**ADDENDUM
NO. 4**

PORTAGE HIGH SCHOOL: 2026 RENOVATIONS PROJECT

Project No. 226023.00

ITEM NO. 1. NEW DRAWING SHEETS

I-203

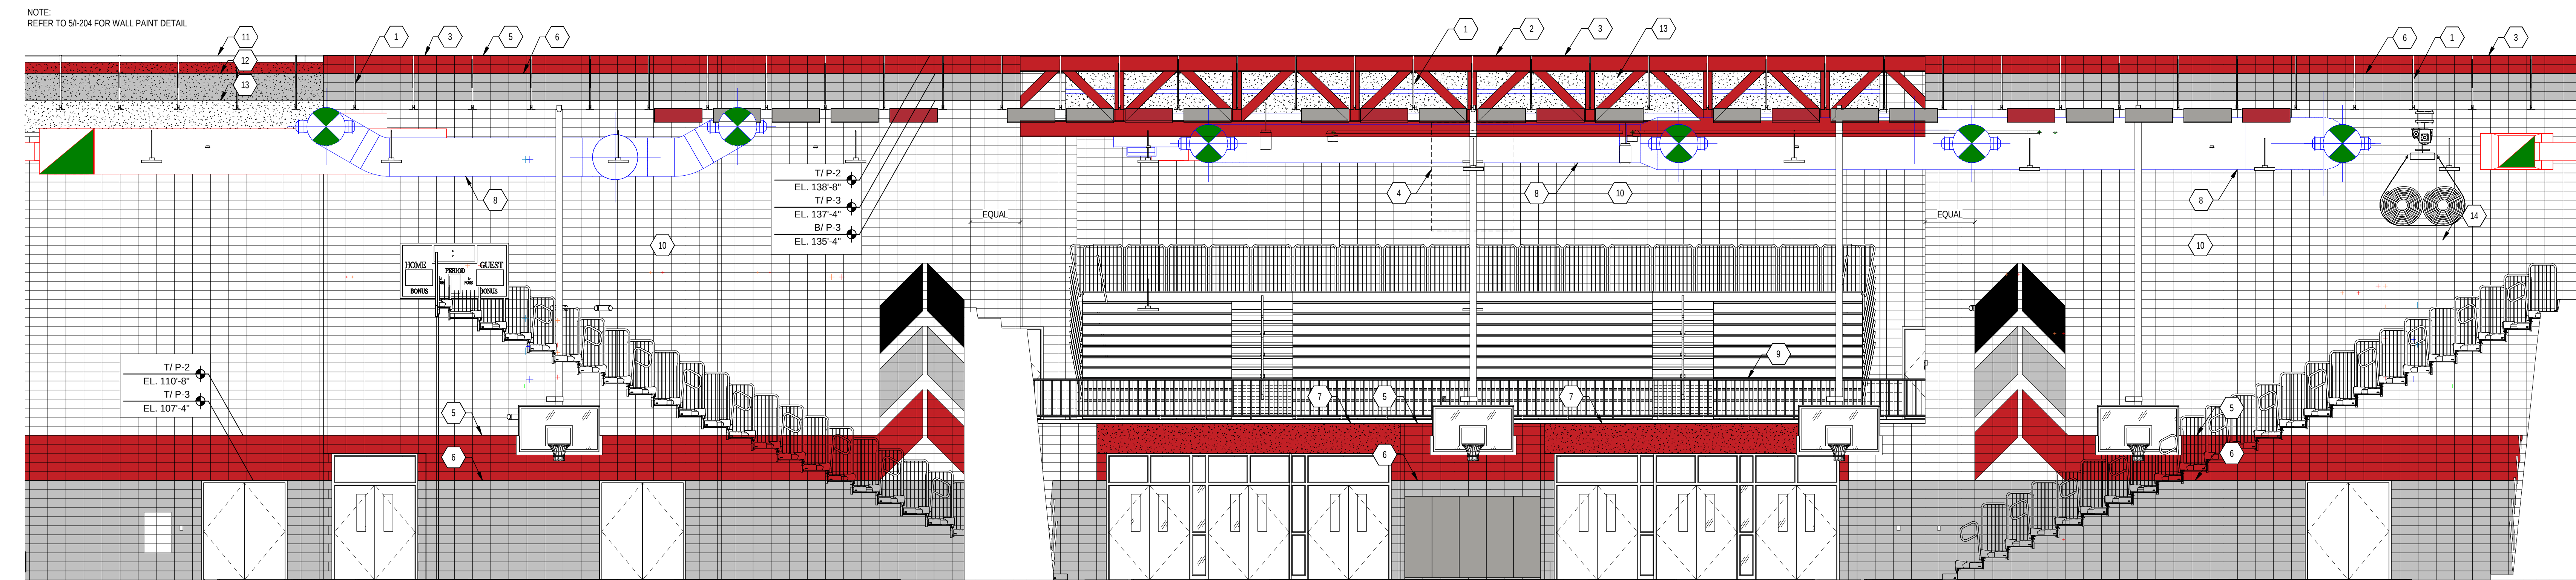
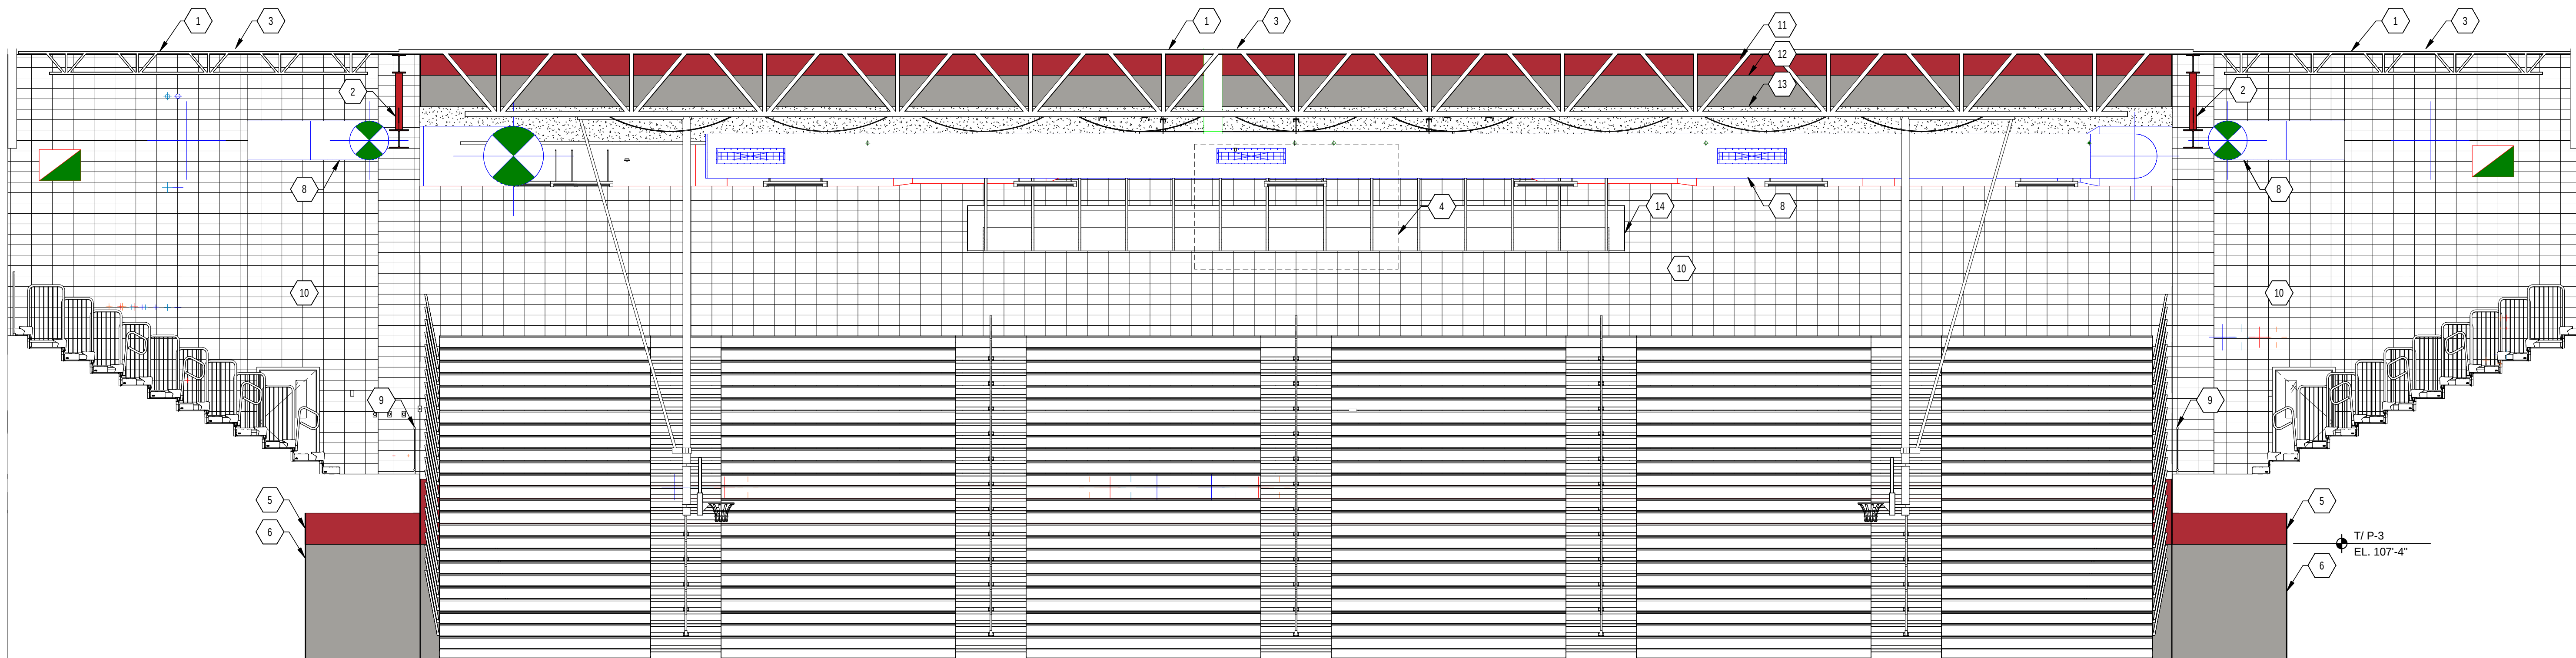
New Drawing Sheets: I-203 and I-204 have been included, dated 9/15/26, and are included with and hereby made a part of this Addendum. These Drawings were show the Main Gym (Unit C) paint extents that were omitted from the original printing.
